TECHNICAL BULLETIN

MODEL/DERIVATIVE:
Defender

Bulletin N°: 0081
CDS. ref: L8708
Issue: 1
Date: 31.10.01

PROBLEM:
FRESH AIR VENT - WATER / DUST INGRESS AND DIFFICULT TO CLOSE

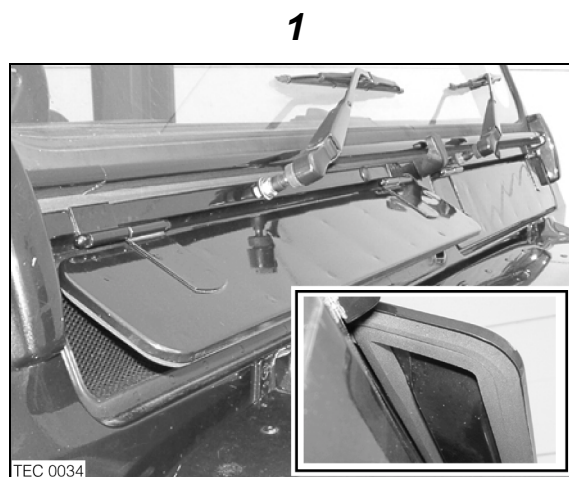
- Water or dust ingress into vehicle through fresh air vent seal.
- Fresh air vent difficult to close.

CAUSE:
Failure of fresh air vent seal material.

ACTION:
Where a complaint of the above is confirmed, follow the procedure below to replace the fresh air vent seal with the improved seal detailed in *PARTS INFORMATION*.

1. Fully open fresh air vent.
2. Remove 2 bolts securing the fresh air vent control arm to fresh air vent.
3. Remove nuts securing hinge pins, release pins and remove the fresh air vent.
4. Carefully remove and discard seal, clean surface to remove any remaining adhesive.
5. Remove backing from the new fresh air vent seal and carefully align it to the edges of the fresh air vent, (inset in illustration 1), press seal firmly home.
6. Align fresh air vent to fresh air vent control arm and finger tighten bolts.
7. Lubricate hinge pins, align fresh air vent to hinges, fit pins and tighten nuts to 6 Nm.
8. If paint finish on nuts is damaged repair as required.
9. Tighten fresh air vent control arm bolts to 10 Nm.
10. Close fresh air vent.

JAE000030 – Fresh air vent seal
